FL MCO FSHUN THREE (RNAV) DEPARTURE

4-14-22 PRB Results: Returned for Rework

# Procedure Review Board (PRB) Results

**Waiver/Approval:** ORLANDO INTL, ORLANDO, FLORIDA (MCO) - FSHUN THREE (RNAV) DEPARTURE,

## FSHUN THREE DEPARTURE (RNAV)

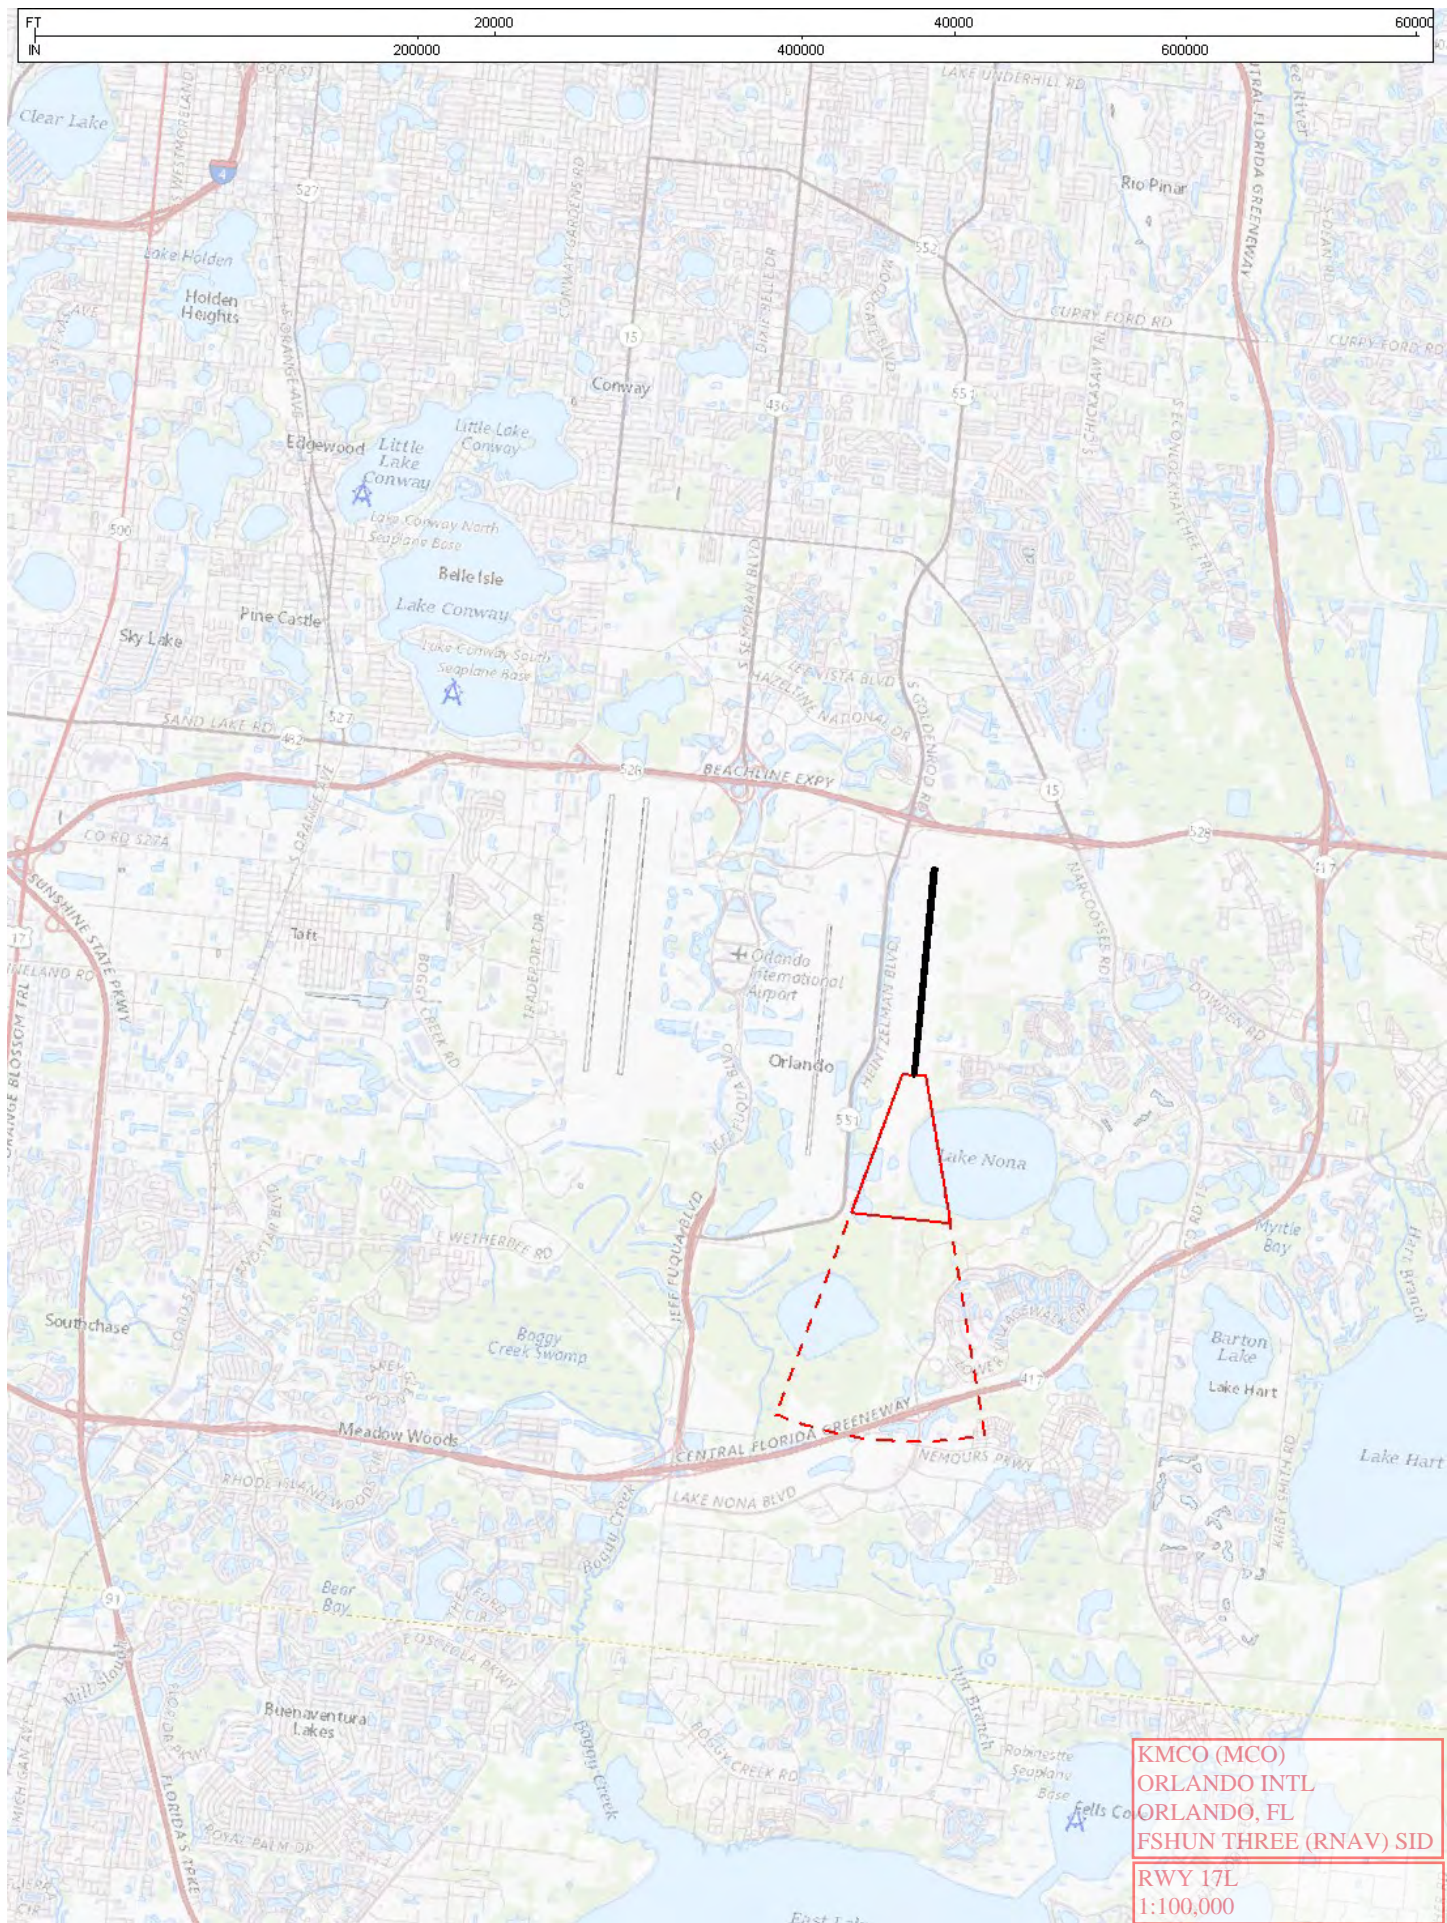
2. 8260.46, para 2-1-1e(2)(b)2 and Appendix E, Section 1, para 3 and Fig E-1: Chart "Then on Depicted Route" and Climb gradients in Departure Route Description as indicated below:

3. Update waiver with above climb gradient description being moved to the departure route description. Add climb gradient evaluations to the package.

4. Based on new position of the climb gradient info: 8260-15B Procedural Data Notes: Delete: NOTE: ATC CLIMB GRADIENT RWY 35R: 566 FT/NM TO 2600, 36L: 637 FT/NM TO 2300, 36R: 621 FT/NM TO 2300, IF UNABLE TO ACCEPT CLIMB RATE ADVISE ATC PRIOR TO TAXI.

**RESPONSE:** **NONCONCUR** with recommendation. The RWY 35 L/R and 36 L/R have altitude speed constraints in the Departure Route Description. Flight Crews could possibly overlook these constraints if only depicted on the chart.

**RESPONSE:** **CONCUR** with recommendation. FLMP will make necessary changes. **COMPLETE**

RESPONSE: Amend ATC CG Waiver as follows: 4. EQUIVALENT LEVEL OF SAFETY PROVIDED: The Graphic Departure Route Description will state: ALL AIRCRAFT: ATC CLIMB GRADIENTS: IF UNABLE TO ACCEPT CLIMB RATES ADVISE ATC PRIOR TO TAXI. RWY 35R: 566 FT/NM TO 2300, RWY 36L: 637 FT/NM TO 2300, RWY 36R: 621 FT/NM TO 2300.
